COMMUNITY BOARD FEEDBACK PACKAGE

DINING OUT NYC

COMMUNITY BOARD RECOMMENDATION FORM

Business Name: Terra Mediterrania	
Cafe Address: 124 7TH AVE, NEV	V YORK, NY, 10011
Application Number: 202407290100	022
CB Review Deadline (on date or next by NYCDOT Internal Use Only	business day): 3/30/2025
Sidewalk Cafe Setup Feedback:	Community Board chooses to WAIVE review
Comments related to the cafe's physical foo Applicant informed MCB4 that the Site Plasubmitted the attcached Revised Site Plasubmitted the attcached Revised Site Plasubmitted the attcached Revised Site Plasubmitted Site Plasubmitted Revised Site Plasubmitted Site Plasubmitted Revised Site Plasubmitted Site Plas	lan of the Sidewalk Cafe submit to DOT was inaccurate and
Comments related to pedestrian flow (i.e., vi	sbility, safety , potential crowding):
Comments related to potential conflicts with	existing curb use (i.e., planters, bike racks, bus stops):
Please check one of the recommendations be the above application:	elow, either approval, denial , or approval with modifications <u>relating to</u>

Site Plan Form

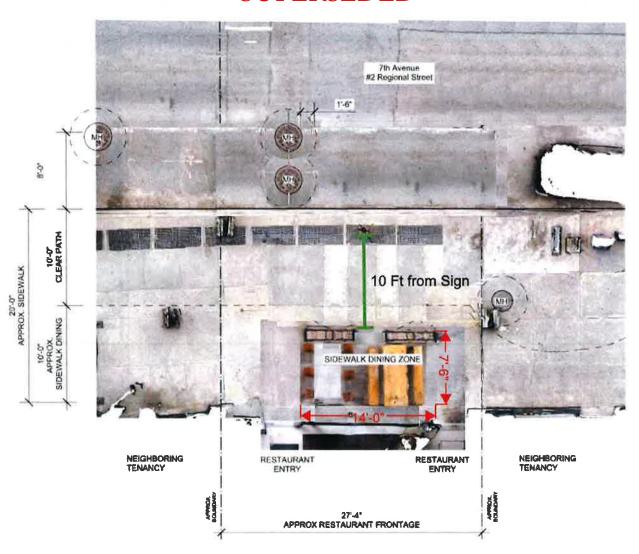
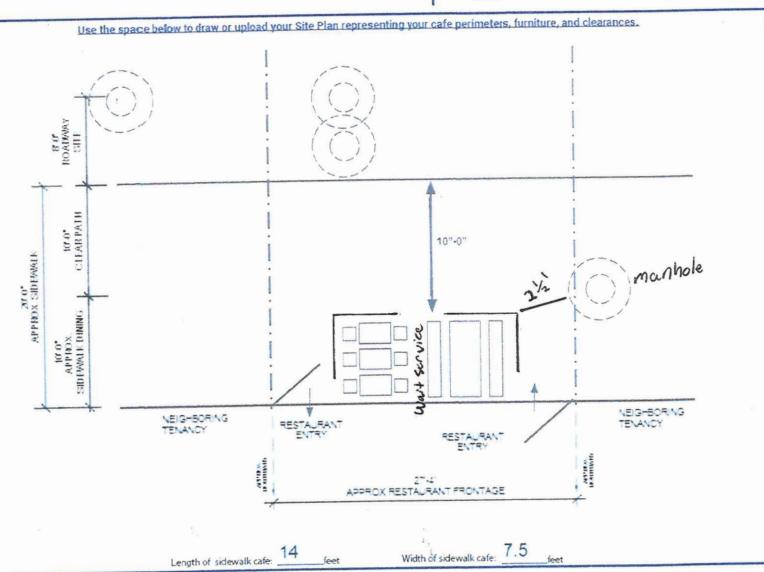
Community Board Authorizing Name On 3/11/25 the Business Licenses & Permits Committee voted to recommend approval with modifications. This application is subject to ratification by MCB4 Full Board on Wednesday, April 2, 2025.

SUPERSEDED

Setup Area Identification: REVISED PLANS
